MIDLINE SWEATER LTD. FACTORY

Baro Boyka, Chandona, Gazipur Sadar, Gazipur-1702

20th February 2019

Observation

Apparently non-engineered light weight roof shed of extension part

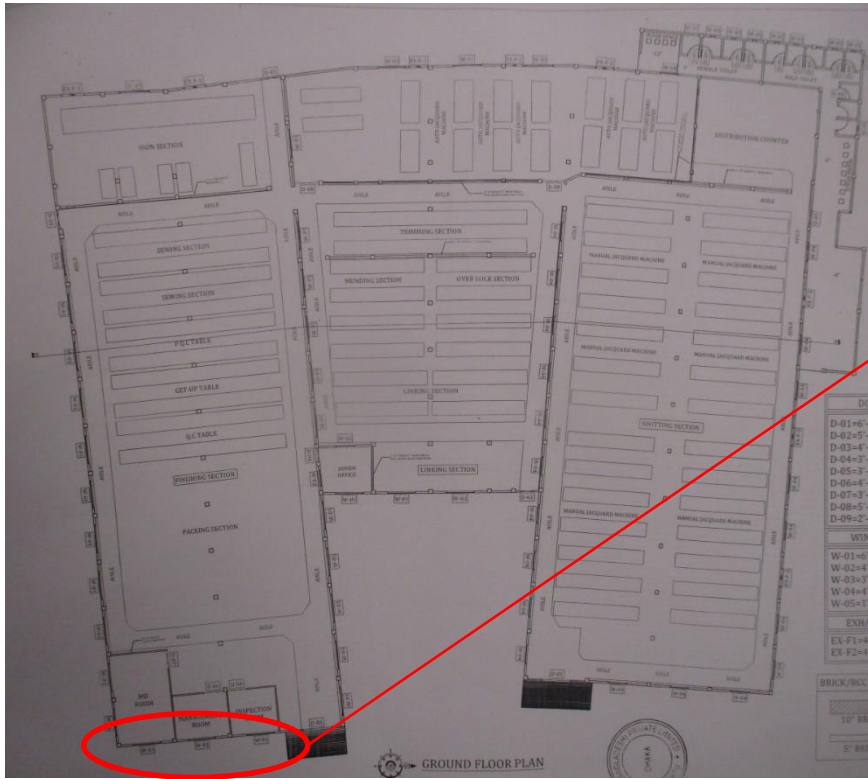
The support condition of the steel roof was not clear and apparently non engineered. Factory is required to replace the existing shed with an engineering shed.
